COMMENTS

The enclosed is responsive to the Examiner's Office Action mailed on January 20, 2004. At the time the Examiner mailed the Office Action claims 1-24 were pending. By way of the present response the Applicant has amended claims 1, 8 and 17 and cancelled claim 2. As such, claims 1 and 3-24 are now pending. The Applicant respectfully requests reconsideration of the present application and the allowance of claims 1 and 3-24.

FIGURE 1

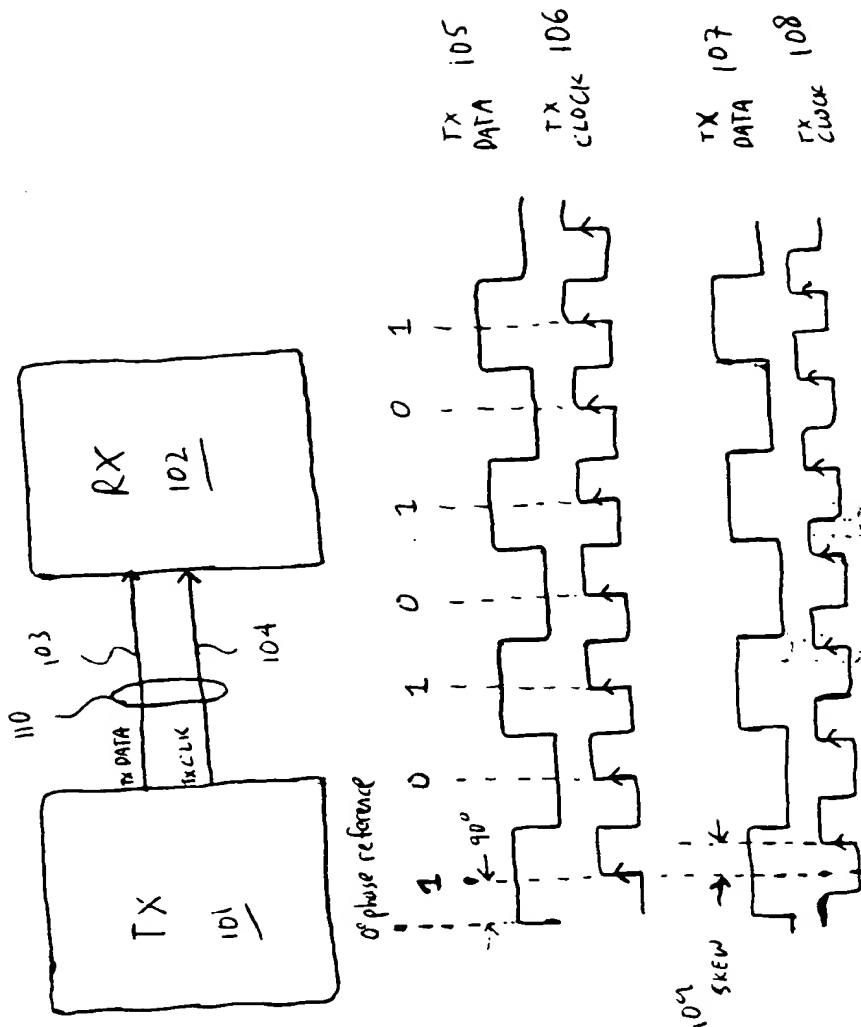
The drawings are objected to because Figure 1 referred to as conventional in the specification on page 1, para. 2 should be designated by a legend such as –Prior Art—because only that which is old is illustrated.

The Applicant has amended Figure 1 to include the legend “Prior Art”. A replacement sheet for Figure 1 is attached with this response.
